**CITY OF NORTH ST. PAUL PLANNING COMMISSION
REGULAR MEETING AGENDA
THURSDAY, APRIL 2ND, 2020
6:15 PM**

A. Final Planned Unit Development (Tveten 7th Street Townhomes)– 2242 7th St. N.

PRELIMINARY PLANS FOR THE
7TH STREET TOWNHOMES
NORTH ST. PAUL, MN
JANUARY, 2020

C20

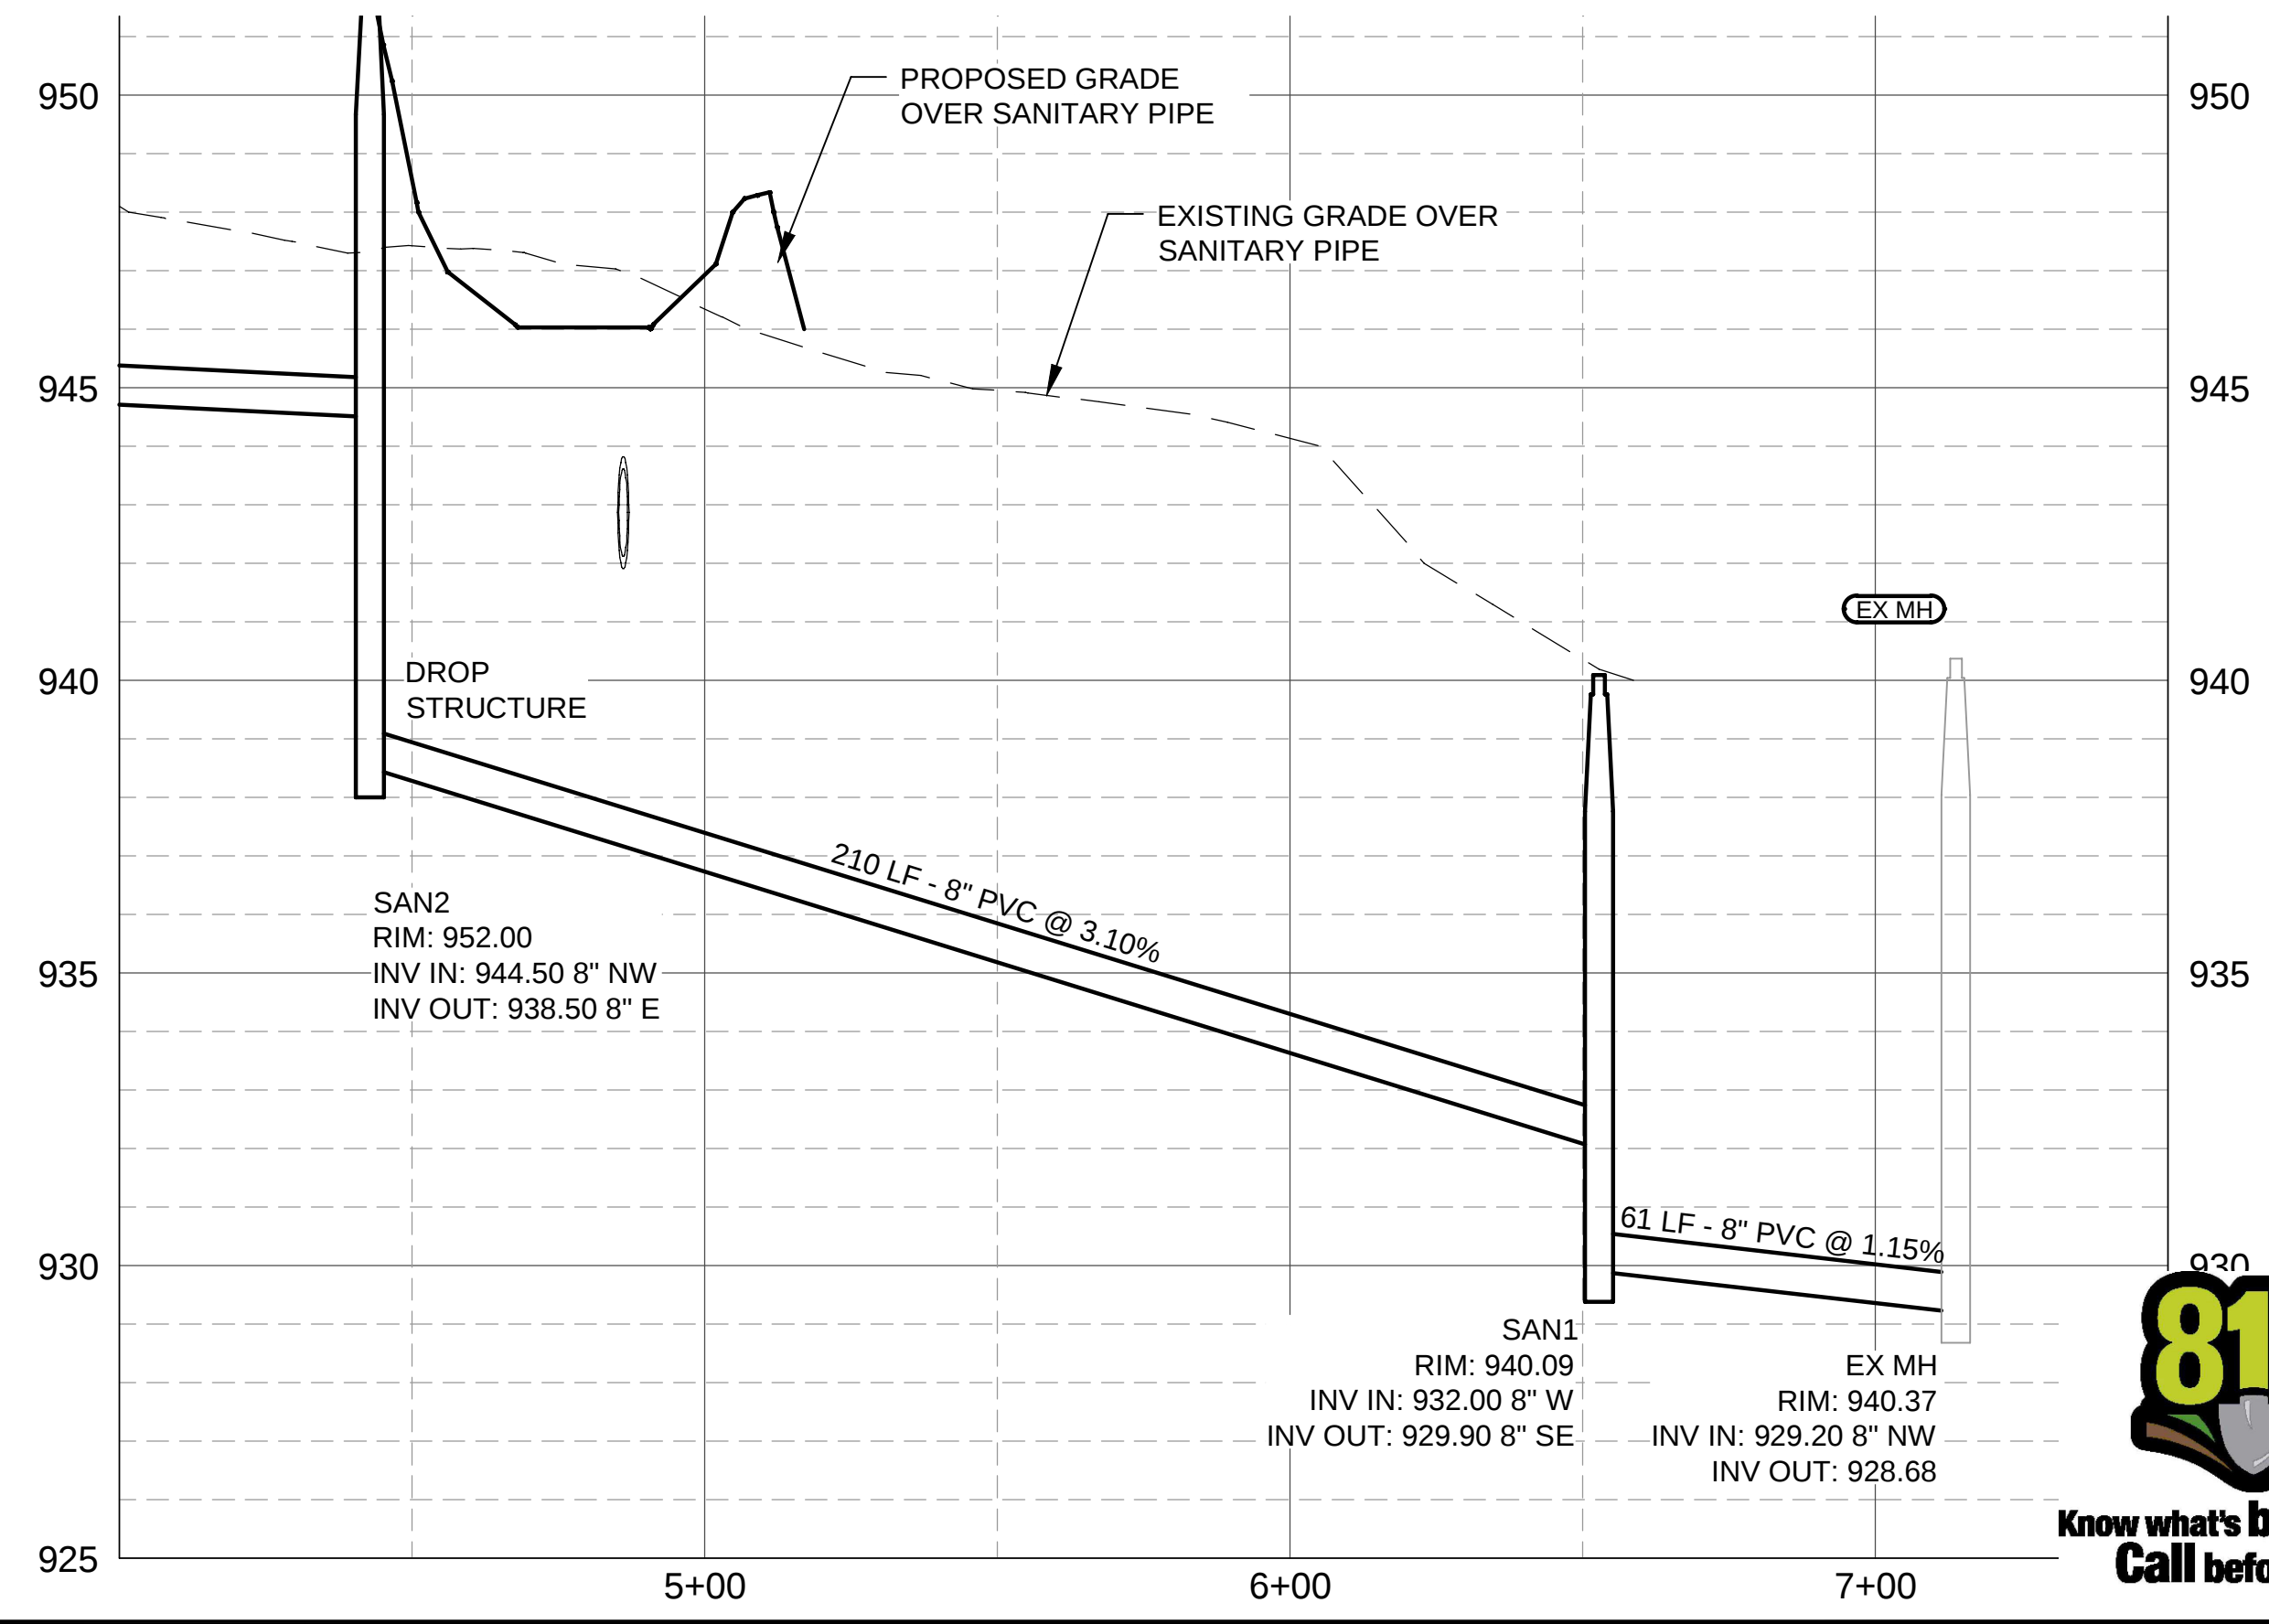
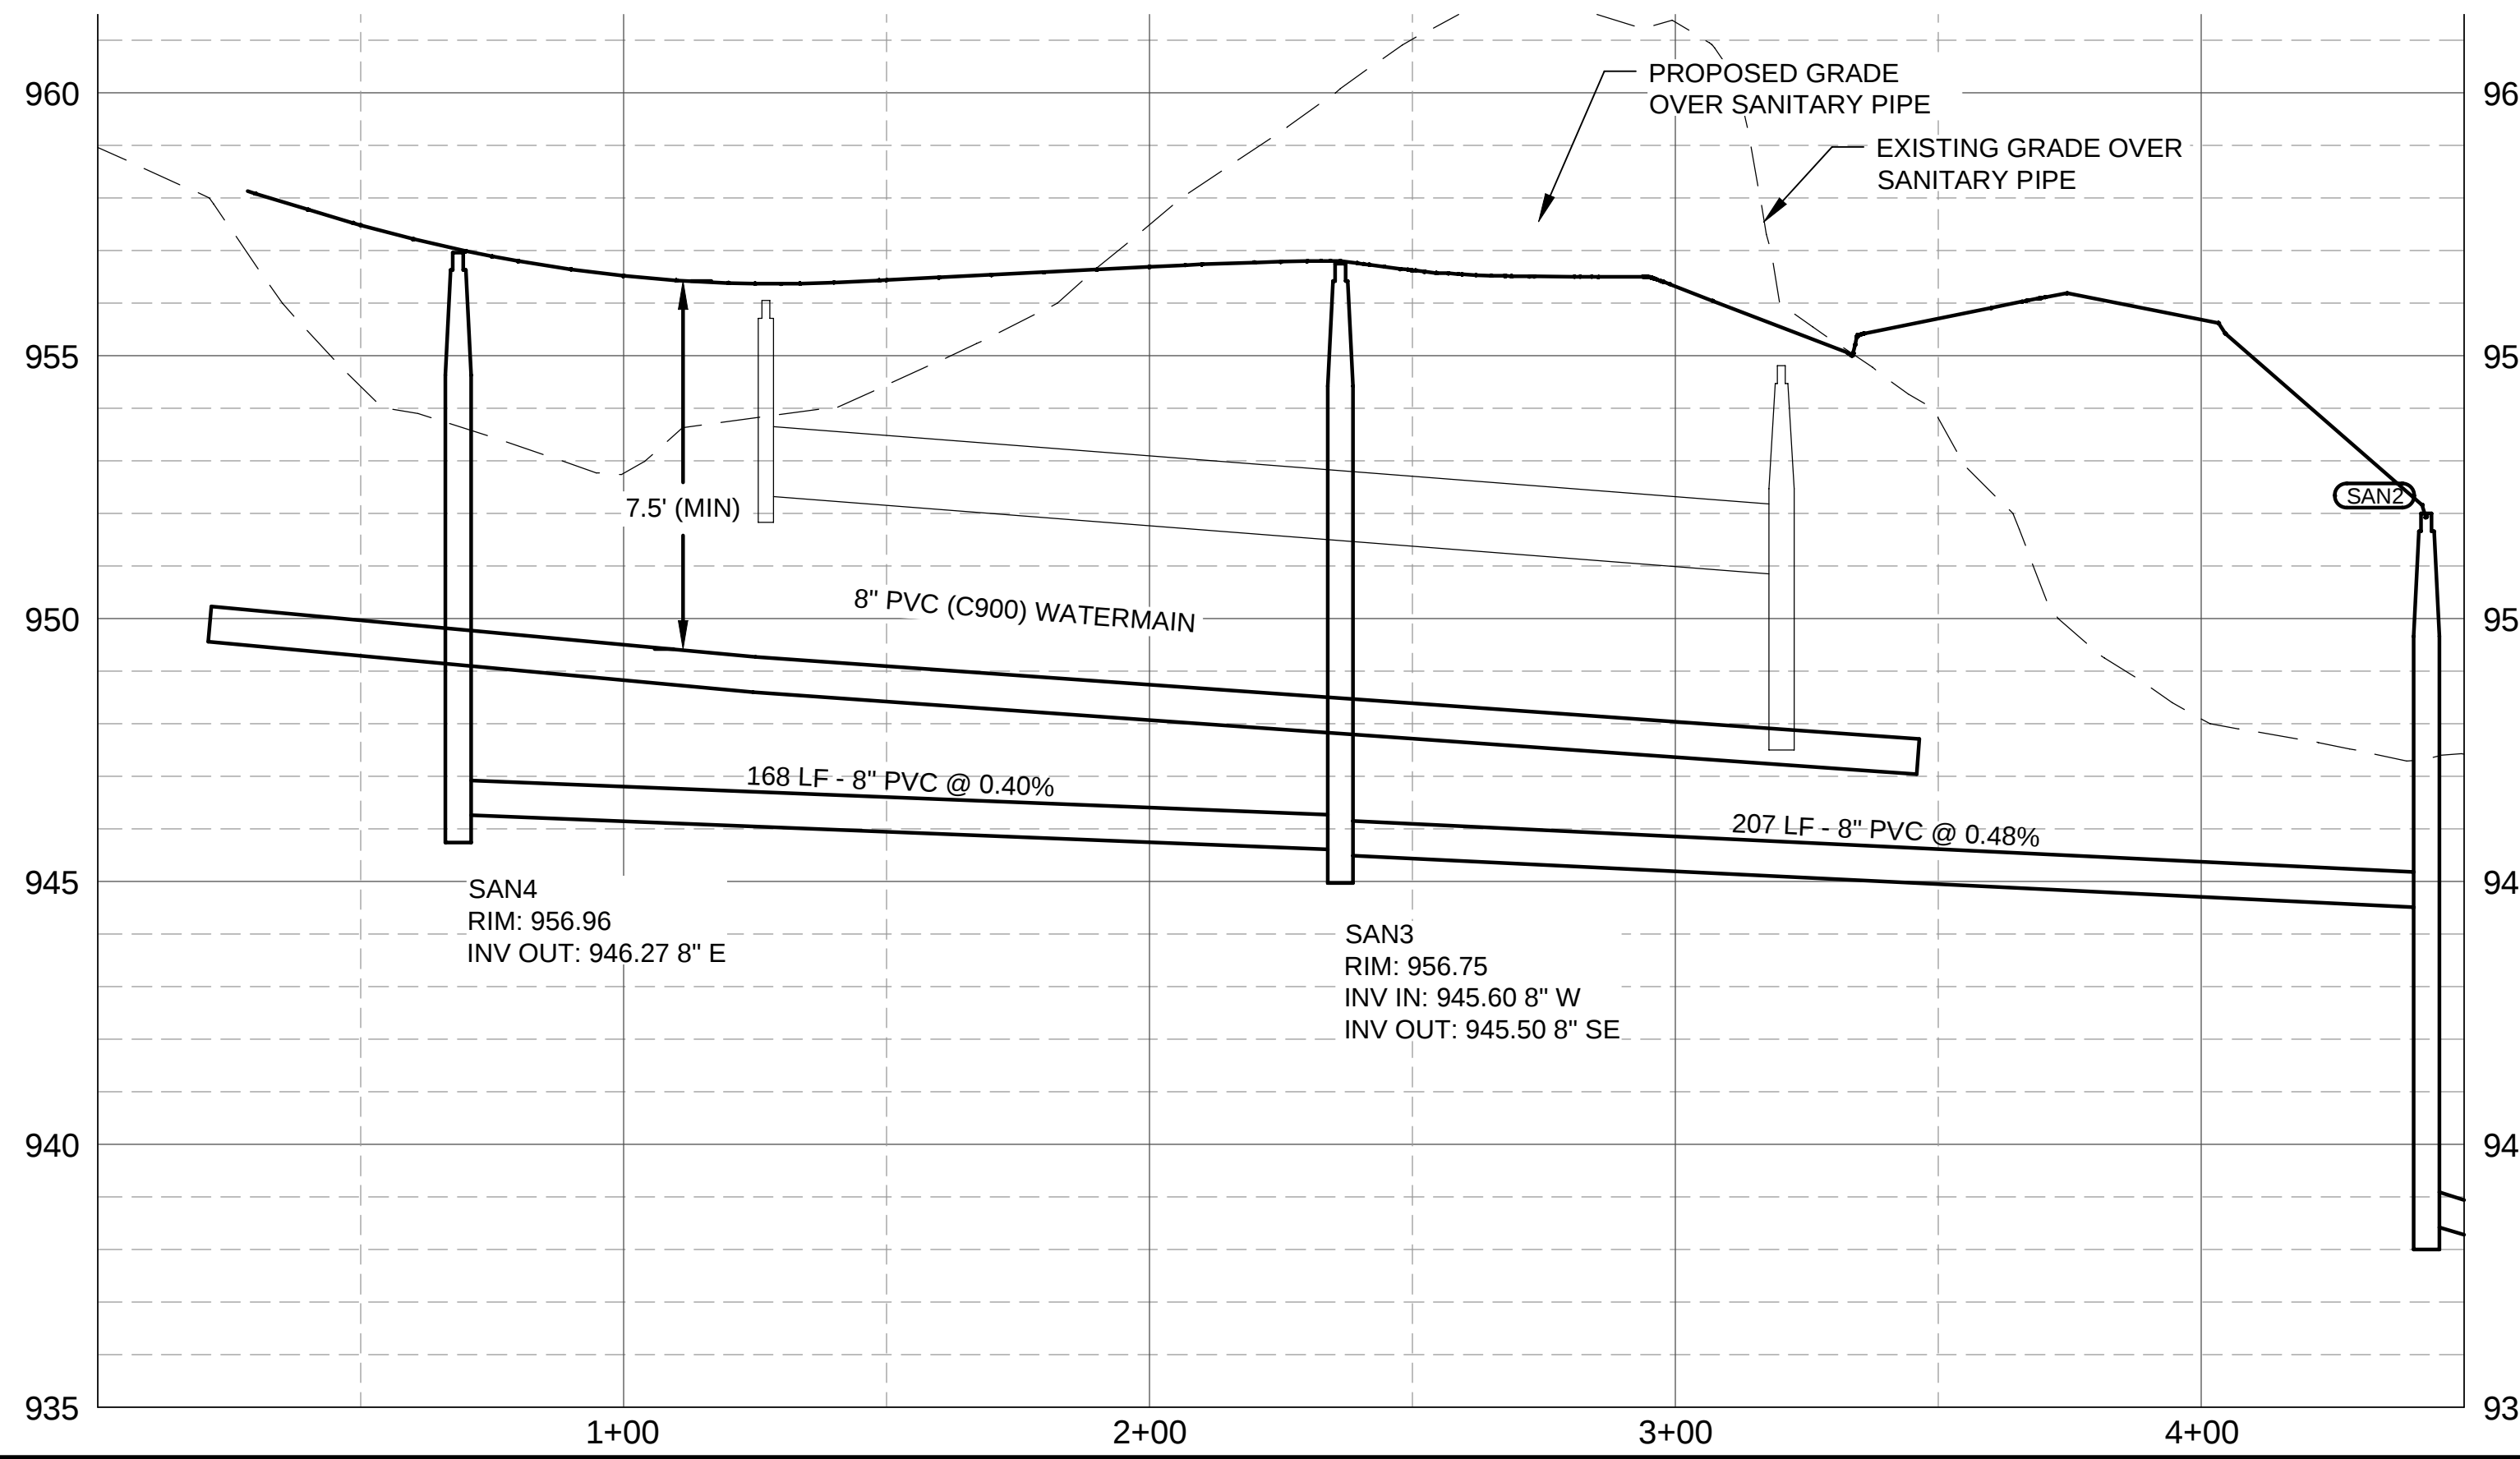
Sheet C30:

1. Show sanitary and watermain in plan view (similar to storm on Sheet C40).
